**OFFICIAL FILING
BEFORE THE
PUBLIC SERVICE COMMISSION OF WISCONSIN**

Application of Northern States Power Company, a
Wisconsin Corporation, for Approval of Parallel
Generation Tariff Modifications and Avoided Costs

4220-TE-109

**DIRECT TESTIMONY OF DIVITA BHANDARI
ON BEHALF OF RENEW WISCONSIN, INC.**

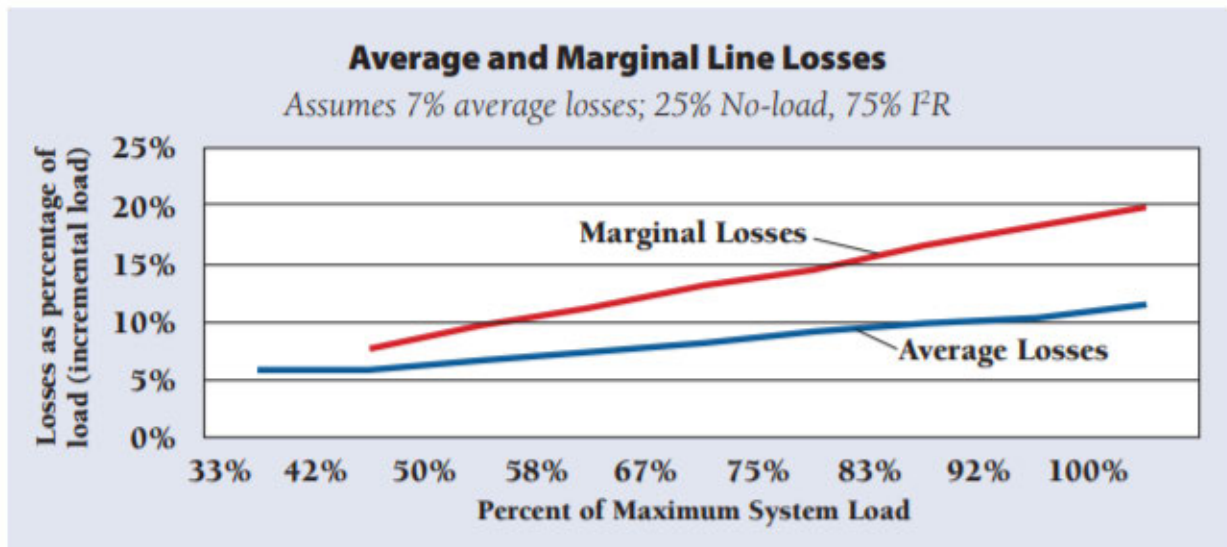
1 **Q. Please describe the relationship between loading and losses.**

2 A. The amount of energy loss in any hour is affected by a number of factors
3 including resistance in wires, system utilization rates, and weather conditions. The
4 formulae for losses is I^2R or the square of the current multiplied by resistance.
5 The “I” on the system is a direction function of the load on the system and
6 therefore increases proportionally with load. Therefore, loss factors are generally
7 higher when loads are higher and are significantly higher during peak periods
8 because resistive losses in wires increase proportional to the square of the load.

19 For transmission and capacity, in addition to the higher marginal loss
20 factors we also have to account for the higher system utilization rates since the
21 investments driven by hours that are at the highest peak. I have estimated a
22 marginal loss factor based on NSPW's average loss factor, and using the
23 relationship between marginal and average losses illustrated in Figure 1 above

1 (from the RAP paper) at high system utilization rates. Based on the data in Figure
2 X, marginal losses are 1.4 times greater than average losses at 50 percent system
3 utilization, and 2.6 times greater than average losses at 92 percent system
4 utilization. Based on this range, I rely on a simple factor of 2.0 to convert average
5 losses to marginal losses during higher system utilization periods, including at
6 peak (and thus for generation and transmission capacity).
